**Re: *Docket No. 461A - Eversource Energy application for a Certificate of Environmental Compatibility and Public Need for the construction, maintenance, and operation of a 115-kilovolt (kV) bulk substation located at 290 Railroad Avenue, Greenwich, Connecticut, and two 115-kV underground transmission circuits extending approximately 2.3 miles between the proposed substation and the existing Cos Cob Substation, Greenwich, Connecticut, and related substation improvements.***

Re: Greenwich Substation and Line Plan  
Development and Management Plan Comments  
Volume II – Part 1 – Cos Cob Substation Modifications  
Town Project No. 18-15

**ATTACHMENT A**

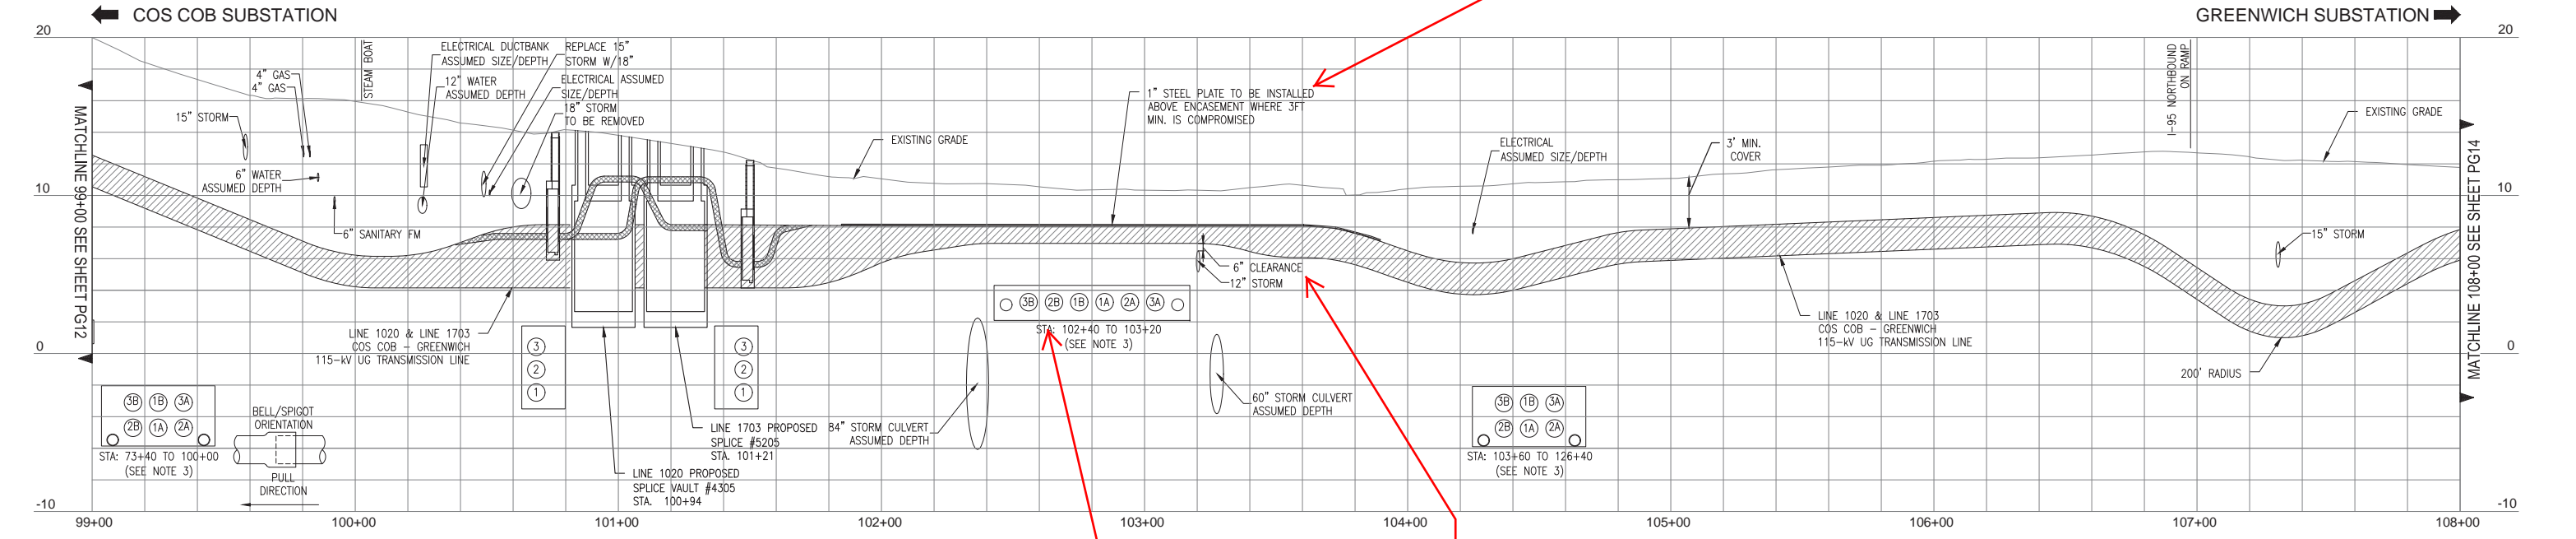
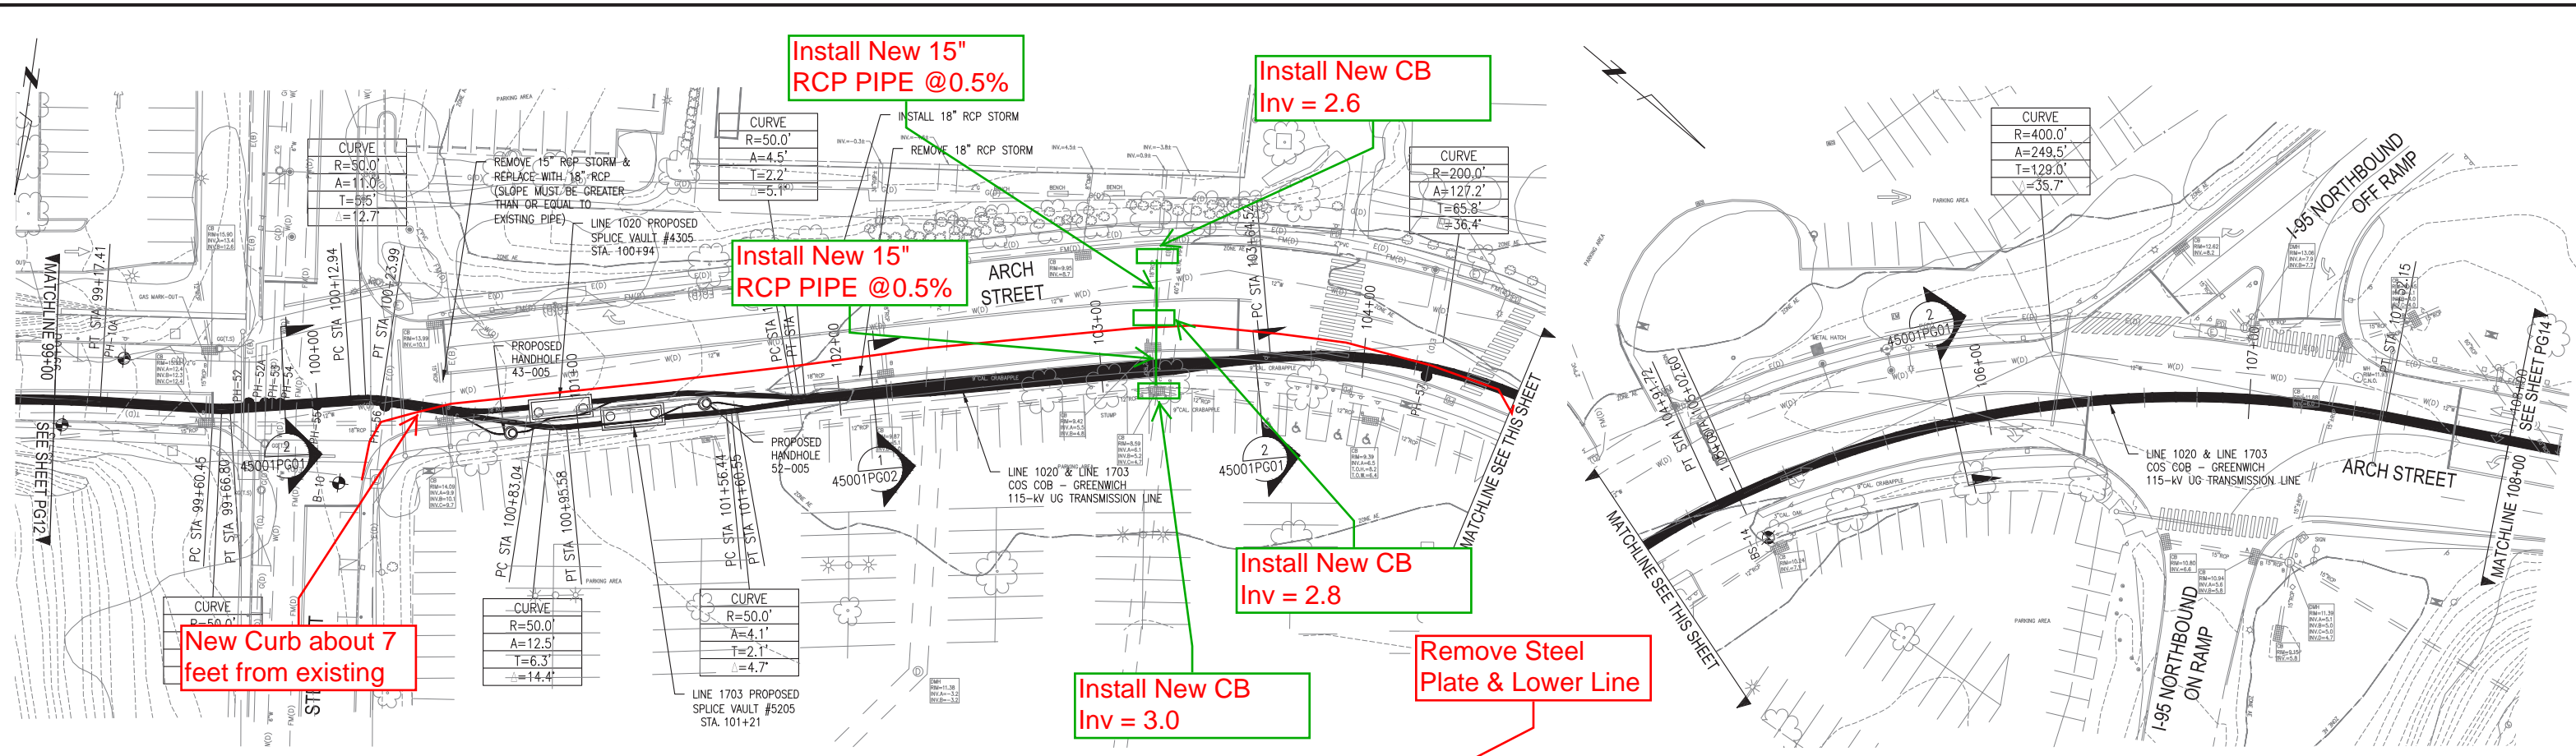
3. The location and details of the duct bank near between Steamboat Road and Exit 3 on Arch St. (Appendix B, Page 13) conflicts with the Town's storm drainage system. As currently designed, the duct bank would impede future maintenance and/or replacement of at least three storm drains, by the installation of a wide and shallow duct bank requiring a steel plate across it for a significant distance. The Town has recommended an alternative design which provides adequate separation distance to the

Town storm drainage system and would address future constructability issues for stormwater infrastructure in this area. A copy of the Town's proposed alternative design is attached hereto as Attachment A. The Town therefore requests that the Council require Eversource to adopt this alternative design to avoid the significant risk of damage to the Town's storm drainage system.
